Access Compliance Report Public Rights-of-Way (Curb Ramps)

Intersection ID: N/A Main Street: S_DAVIDSON_ST Cross Street: N/A Location: S

ADA ID: AC92CA27F23C Ramp Type: Perp Initial Pass/Fail: Fail Overall Compliance: No Severity Score: 37.5

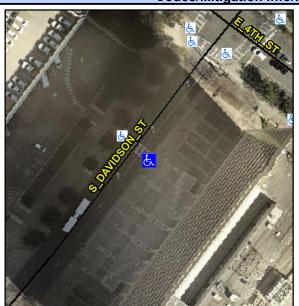
Not Found, R304.2.2, R304.5.3

Field Measurements/Component Compliance					
Comp	liance Description	Data	Comp	liance Description	Data
N/A	Ramp Length (in)	72.0	No	Ramp Slope (%)	9.5
Yes	Ramp Width (in)	95.0	No	Ramp XSlope (%)	7.5
N/A	Flare Type LT	N/A	N/A	Flare Type RT	N/A
N/A	Flare Slope LT (%)	N/A	N/A	Flare Slope RT (%)	N/A
N/A	Flare Traversable LT?	No	N/A	Flare Traversable RT?	No
N/A	Landing Length (in)	N/A	N/A	DWS Provided?	N/A
N/A	Landing Width (in)	N/A	N/A	DWS Contrast?	N/A
N/A	Landing Slope (%)	N/A	N/A	DWS Length (in)	N/A
N/A	Landing X Slope (%)	N/A	N/A	DWS Full Width?	N/A
N/A	Landing Curb? (Y/N)	N/A	N/A	DWS Offset (in)	N/A
N/A	Shared Landing?	N/A			
N/A	Gutter Ponding?	N/A	N/A	Gutter Slope (%)	N/A
N/A	Gutter Lip Ht (in)	N/A	N/A	Gutter X Slope (%)	N/A
N/A	Painted X Walk1?	Yes	N/A	Painted X Walk2?	N/A
	X Walk 1 Direction	To NW		X Walk 2 Direction	N/A
N/A	X Walk 1 Width (in)	105.0	N/A	X Walk 2 Width (in)	N/A
	X Walk 1 Slope (%)	2.3		X Walk 2 Slope (%)	N/A

Remove & Replace Entire Ramp.
